NED-85-422
1746N

NRC DOCKETS 50-321, 50-366
OPERATING LICENSES DPR-57, NPF-5
EDWIN I. HATCH NUCLEAR PLANT UNITS 1, 2
PROJECT COMPLETION ADDENDUM TO RECIRCULATION
PIPING REPLACEMENT REPORT

PROJECT COMPLETION ADDENDUM TO
RECIRCULATION PIPING REPLACEMENT
REPORT TO NRC

FIGURE 2

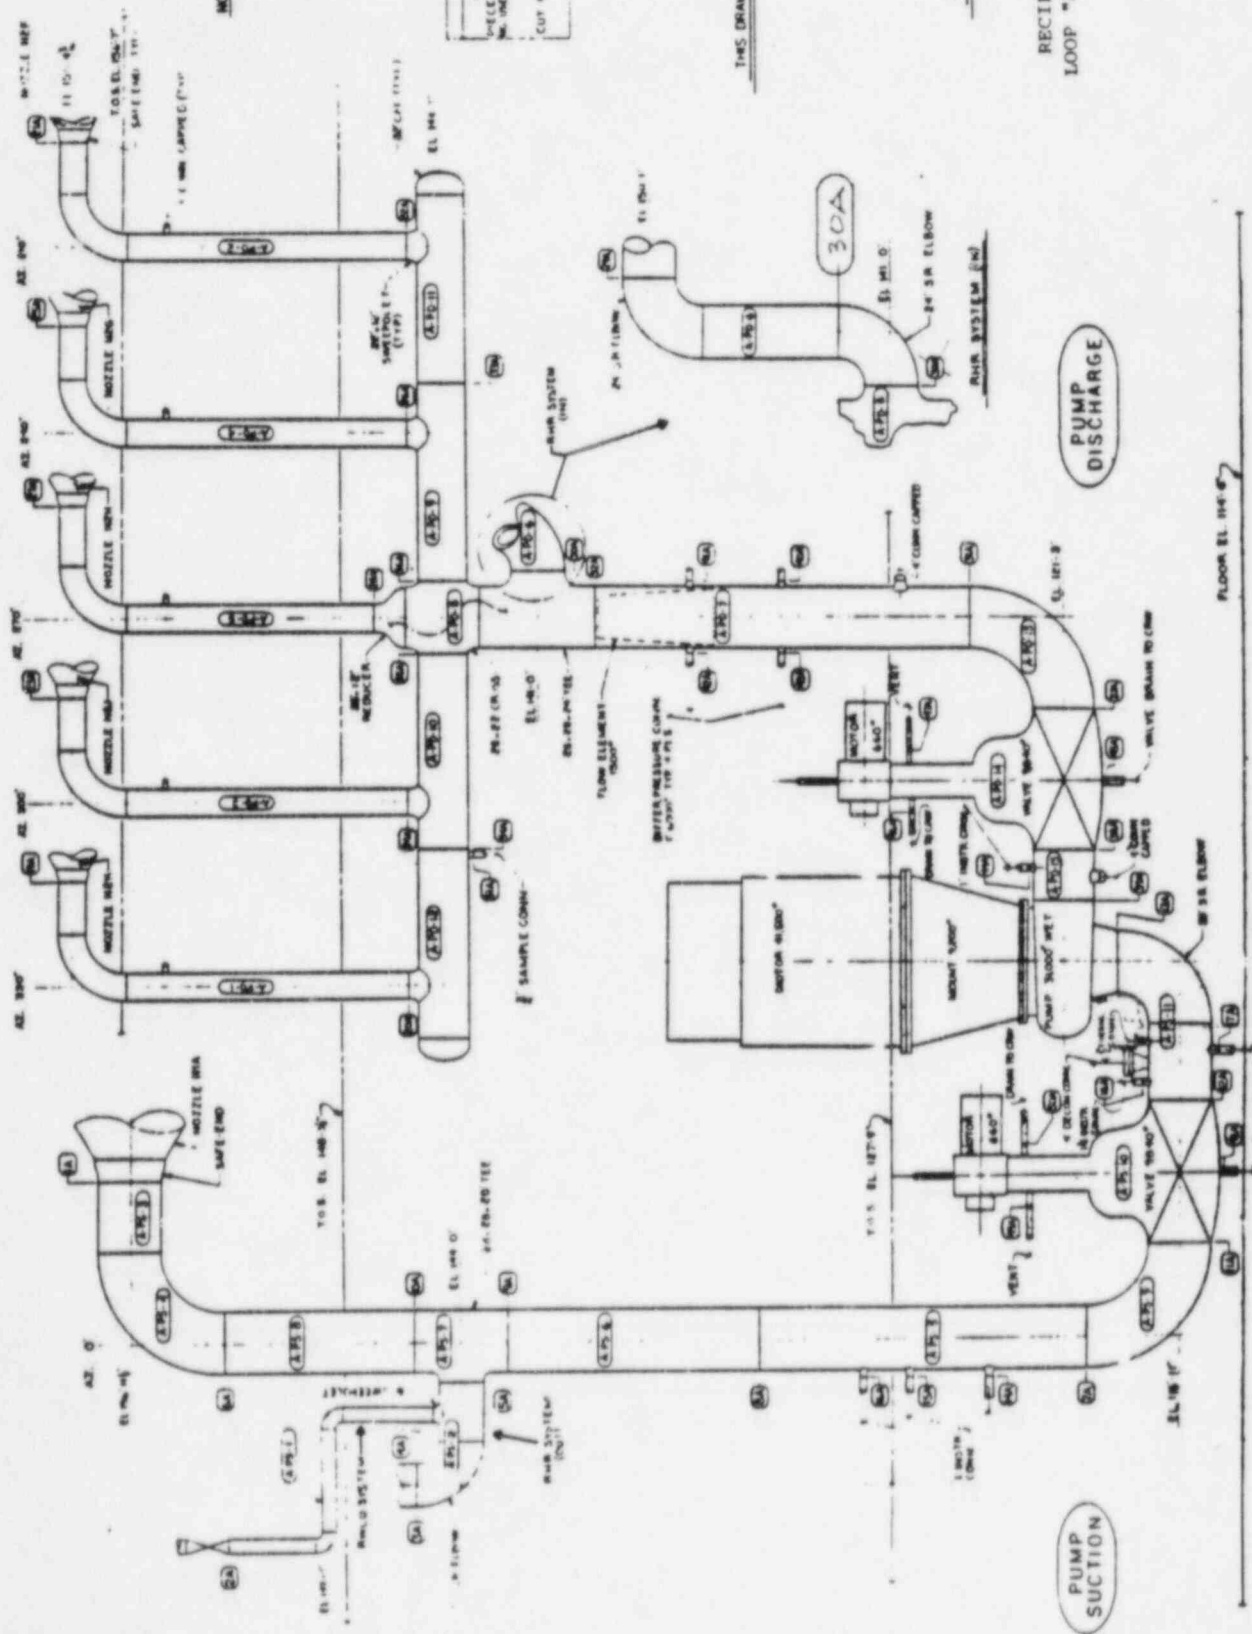
Page 3-11, Figure 2 provides the cutting diagram for Loop "A" of the main recirculation and attached systems' piping. Cut 30A, which severs the 20" RHR piping from the 28" Recirculation System piping, is incorrectly located. Cut 30A should have been located at the adjacent RHR weld (i.e., at the pipe-to-elbow weld) as shown in the enclosed figure.
